ENVIRONMENTAL REVIEW TEAM REPORT

THE BABCOCK PROPERTY GREENWICH, CONNECTICUT

MARCH 1980

FIGURE I. PUBLIC SAFETY CENTER SIMPLIFIED SITE PLAN

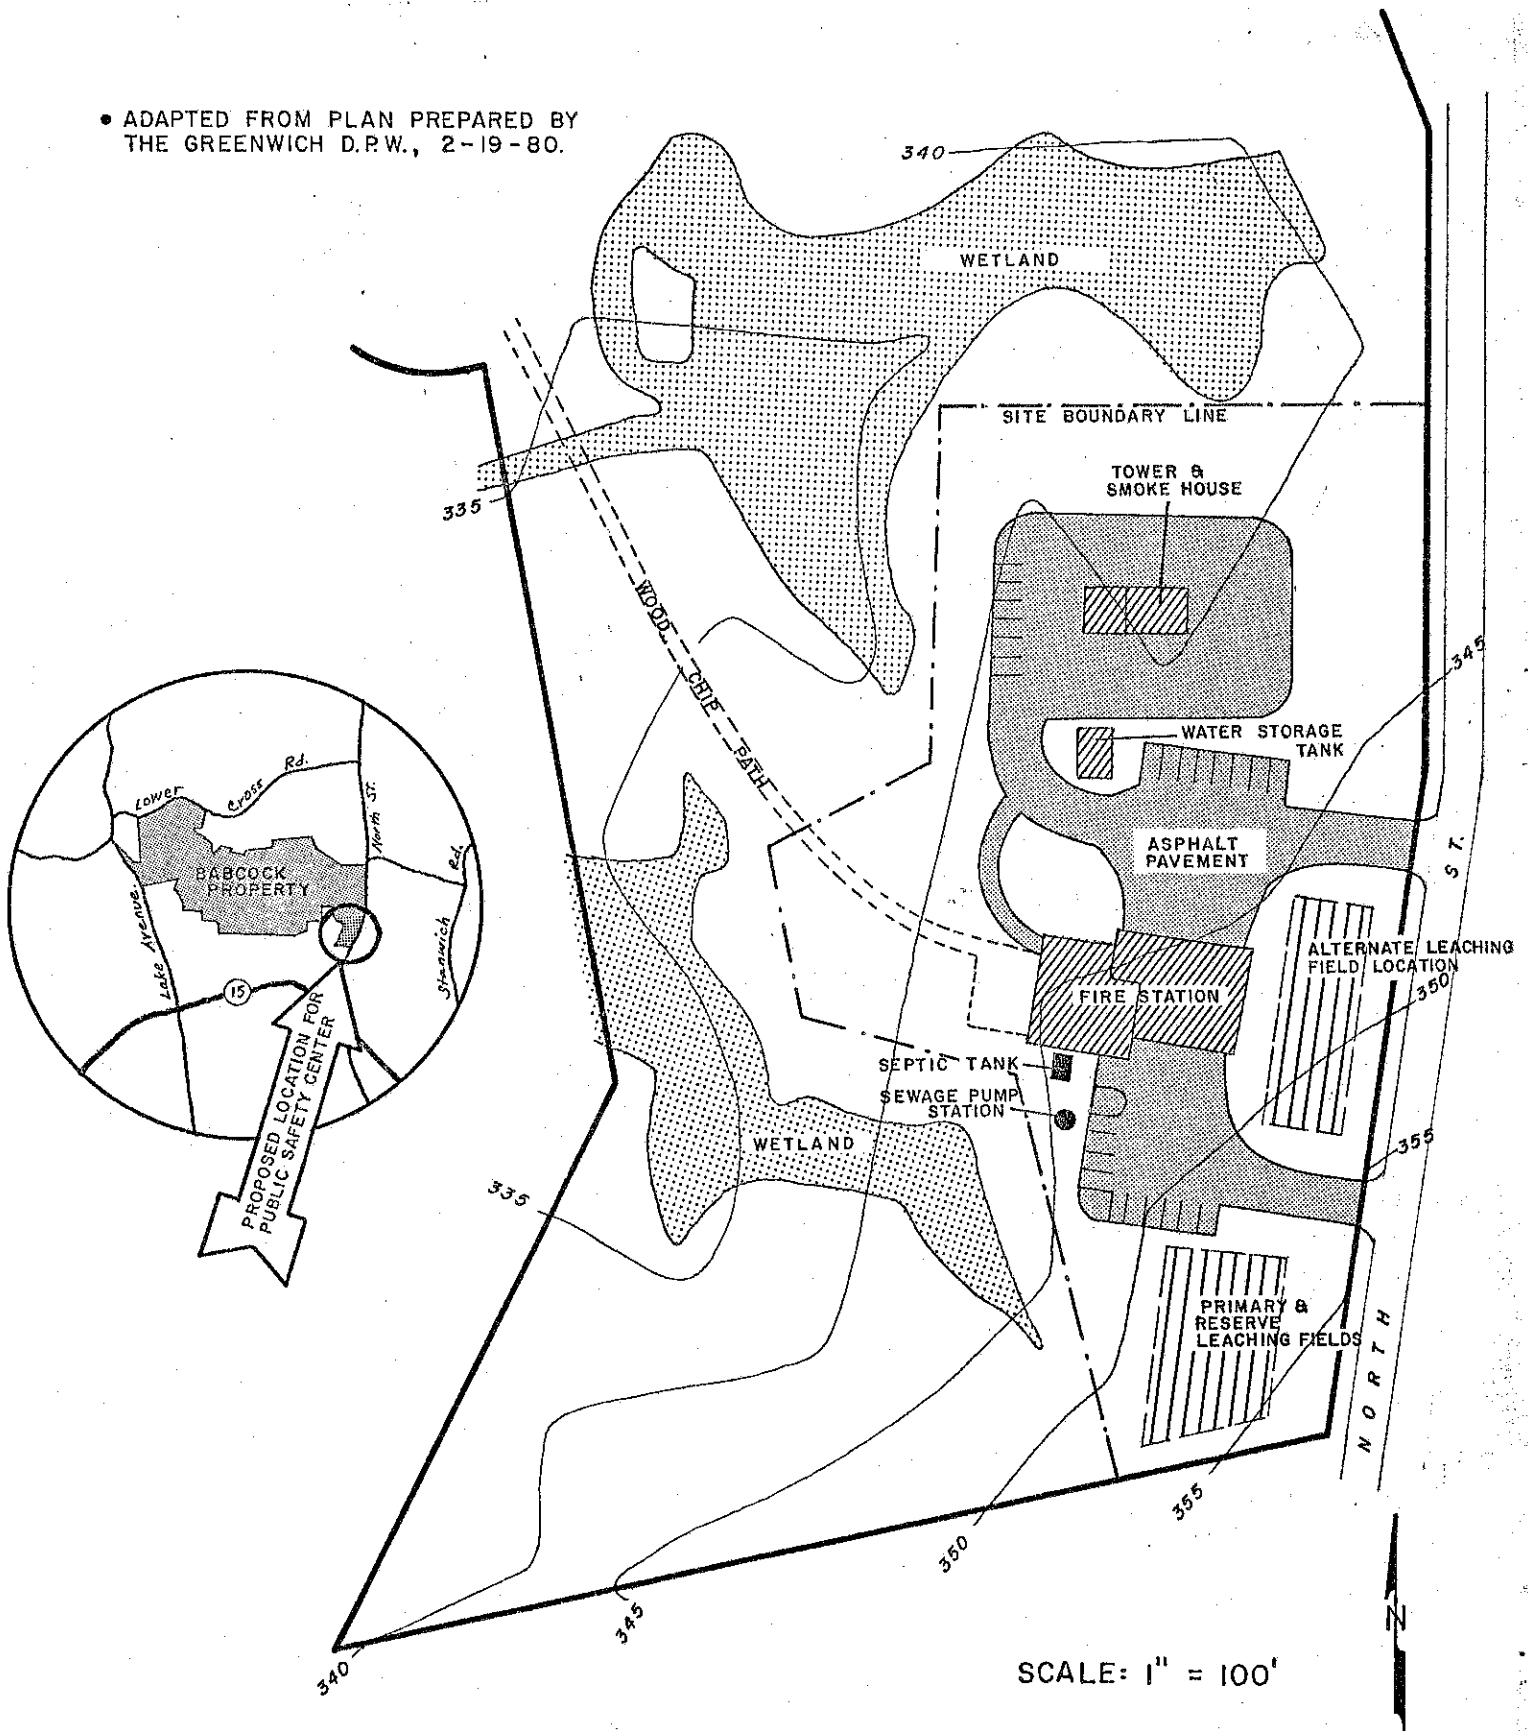
The portion of the property proposed for the public safety center is perhaps the only portion that can avoid these problems. Wetland crossings are eliminated, substantial reworking of the topography is not required, and soil depths are suitable. Some filling may be required for the septic-system leaching field if groundwater is found to be seasonally high, but this would be a minor problem because of its very limited scope.

- a. The sanitary sewage from the fire station would be discharged to either a conventional subsurface disposal system or, in the event that the site is not suitable for such a system, a holding tank. The town of Greenwich has recently performed site testing including deep test holes and percolation tests which indicate to them that a subsurface disposal system could meet state requirements and function properly on the site. The discharge of strictly sanitary sewage to the groundwater on this site could be permitted by the DEP subject to public hearing and approval of plans and specifications.

- b. There appears to be no other acceptable method of disposal of apparatus and equipment washwater besides hauling it from the site. This washwater could contain trace concentrations of oil, gasoline, or solvents; the latter contaminant being present in many commercial automotive cleaning agents. For this reason, the washwaters could not be discharged to either surface or groundwaters, due to the threat of contamination of waters conveyed to Putnam Lake.

The Town of Greenwich has tentatively proposed to wash all apparatus inside the fire station and to collect wash waters in a holding tank for subsequent transport to the Greenwich Sewage Treatment Facility. The DEP would require that both an approval of plans and specifications, and a permit be obtained for any holding tank and waste hauling operation.

- c. There will be a third type of wastewater to dispose of from the fire training tower area. This waste will consist of the waters which fall within the tower area during the sessions of equipment use training and fire fighting practice. This wastewater is of an undefined character and represents an unknown source of contamination to the waters of the state. It has tentatively been proposed by the Town to use clean water only in this area and to collect only that water which falls within a sloped area on the pad surrounding the tower. Any overspray which falls outside of the pad or on portions of the pad which are a certain distance from the tower, would not be collected and would runoff to the storm drainage system. In their tentative plans, the Town has proposed to provide both settling and skimming for the collected tower water to remove any settleable or floating particles. This treated water would then need to be disposed of.

The Department of Environmental Protection has expressed its concern for the quality of this wastewater due to limited experience with waters of this type. Management and supervision deficiencies could arise in the future when utilization of the training tower is made by those groups not completely familiar with all the restrictions of the towers use. To attempt to assure the DEP that this water would be clean, the Town has proposed many restrictions on the materials to be burned in the tower as well as prohibition of anything but clean water to extinguish fires. If these restrictions were strictly adhered to, it is possible that the water could be considered "clean" enough to allow discharge to a Class A stream.

The DEP is concerned that at times, there could be inadequate supervision of the training tower operation and that materials would be burned that could cause contamination of the water used to extinguish the flames or that materials such as chemical foams might be used to control training fires. It would take only a very small quantity of kerosene or other chemical to cause undesirable concentrations in the discharge water.

The Town has tentatively proposed to pump the treated tower water to Rockwood Lake Brook which flows out of Rockwood Lake Reservoir. This is a Class A stream which administratively could receive a clean water

discharge; however, this stream is very small and, until the DEP receives detailed information, there is a strong tendency to doubt whether this wastewater could always be classified as "clean" water. A visual inspection of Rockwood Lake Brook indicates that it may have no flow at all in late summer. There still remains the option of collecting this water in a holding tank for treatment and/or disposal off site. Again, this would require that a permit be obtained.
